UNION PLACE

PRE-HEARING SUBMISSION-SUPPLEMENTAL FILING

ZONING COMMISSION CASE NO. 01-28

Re: ZC Case No. 01-28-200 K Street, NE PUD Modification and Time Extension

Item E Attachment: Building Materials

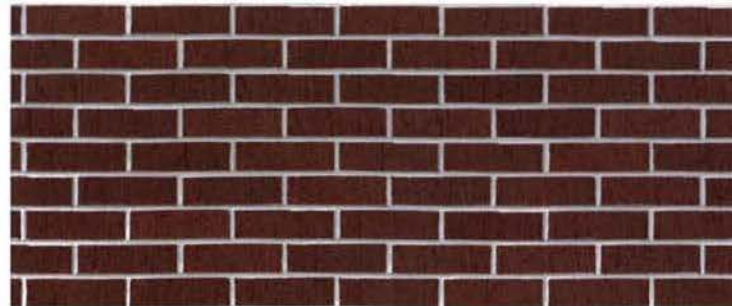
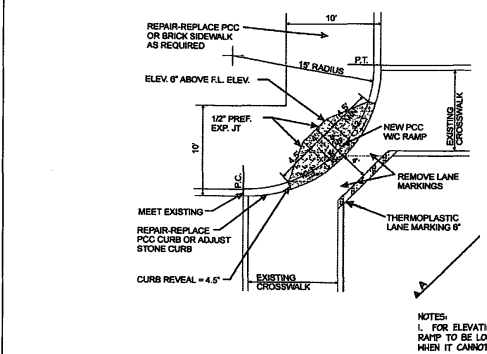
Item E: Specify the Consolidated PUD’s Building Material

Response: A new exhibit has been created to illustrate the proposed use of materials. The locations of the materials as proposed have been keyed to a partial elevation to show their relative position on the façade. The new exhibit is attached.

Item G Attachment: Streetscape & Site Furnishings

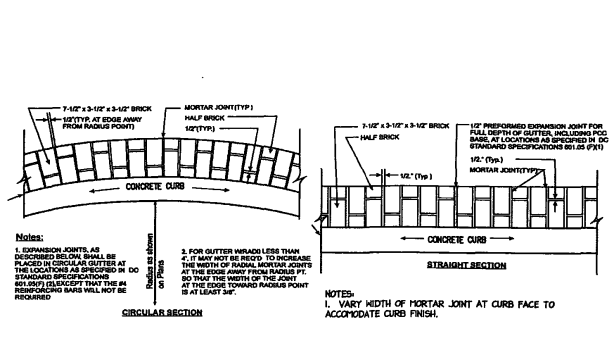
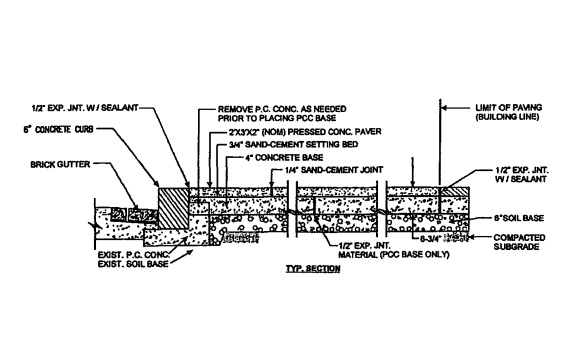
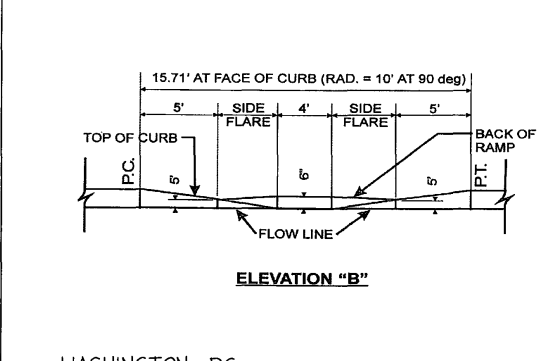
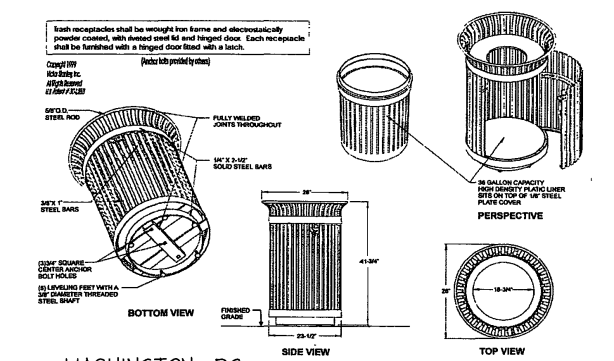
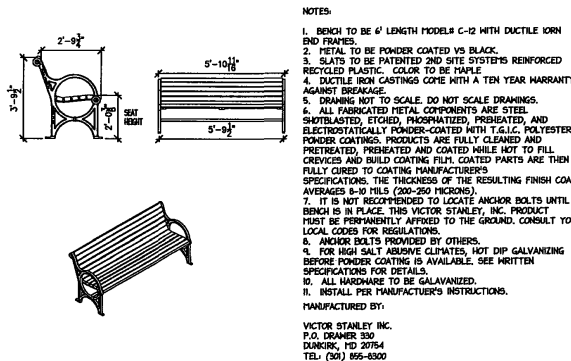
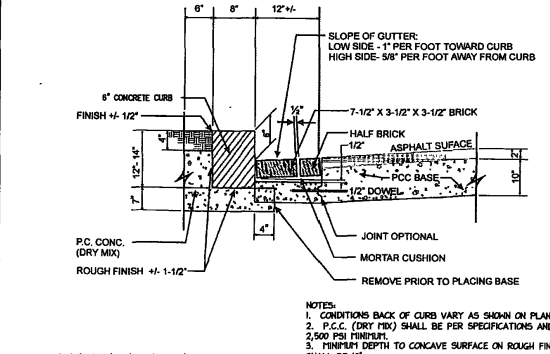
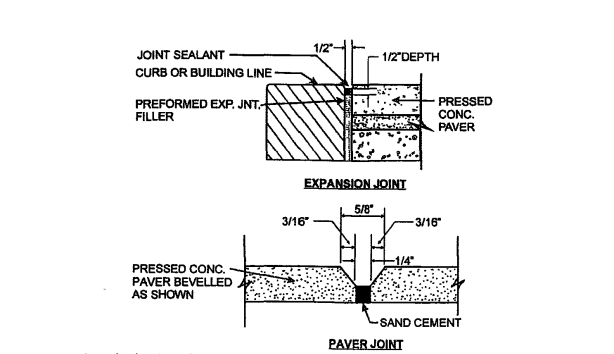
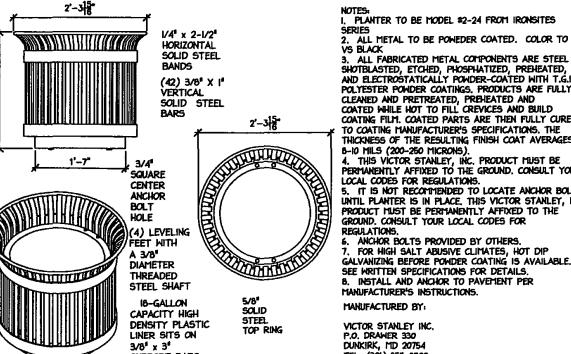
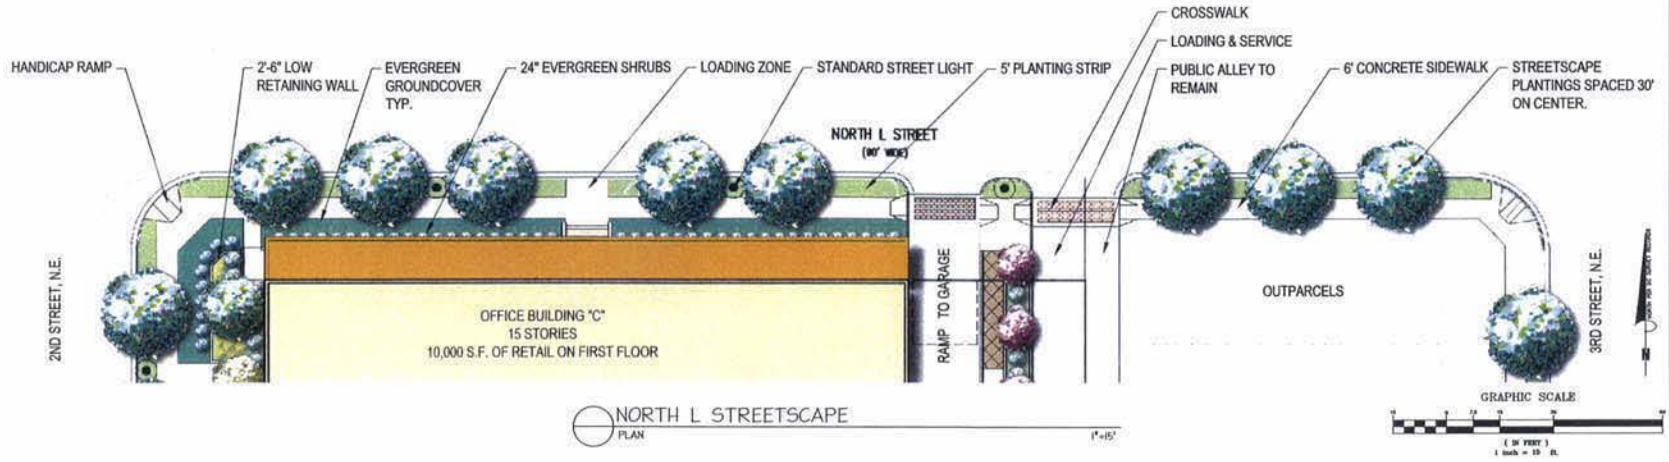
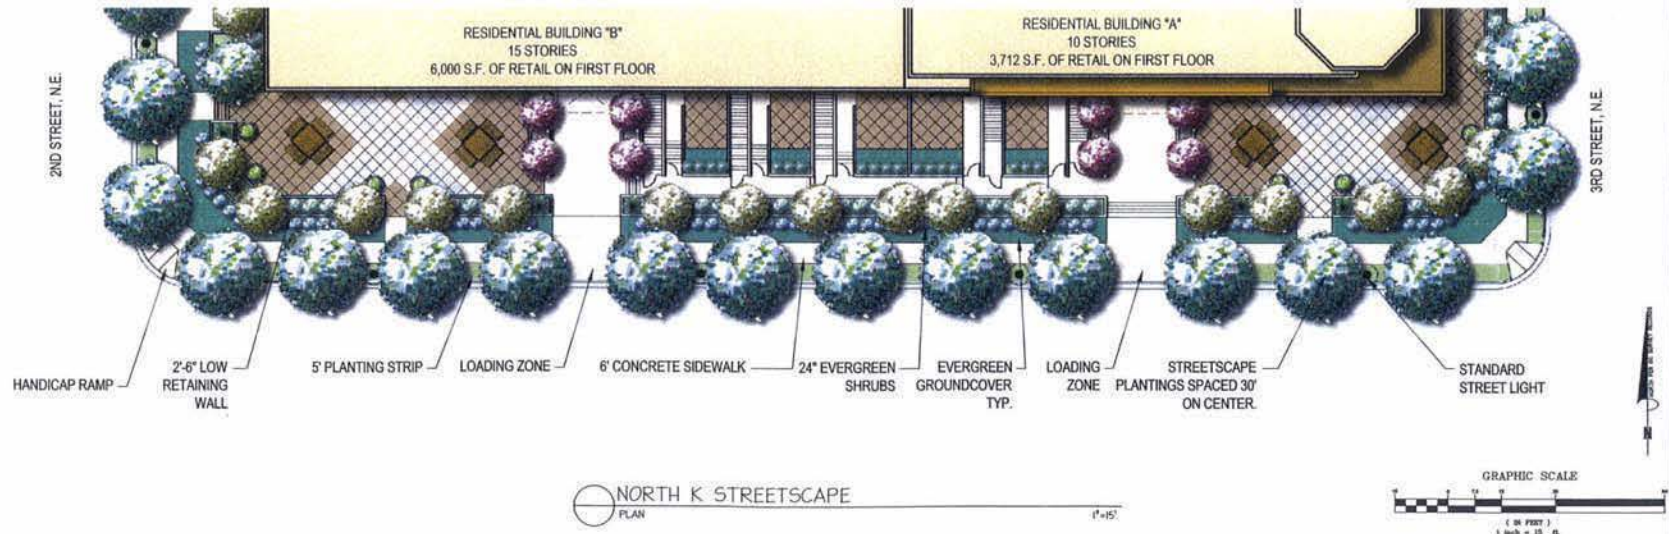
Item G: Improving the streetscape consistent with the H Street design standards for residential streets adjoining the H Street corridor.

Response: Further conversation with Steve Cochran of the Office of Planning concluded the H Street Design Standards are not applicable, but the OP would like to see something that reflects a streetscape similar to that which is adjacent to the property. Based on discussions with DCDOT, we revised Sheets L-6, L-7, and L-8 to update streetscape and site furnishings. A copy of the revised sheets is attached. We will continue to work with the DCDOT on matters such as fencing, walls, project signage, and building encroachments such as steps and risers that may project into the public right of way. We are also amenable to an alternative streetscape concept.
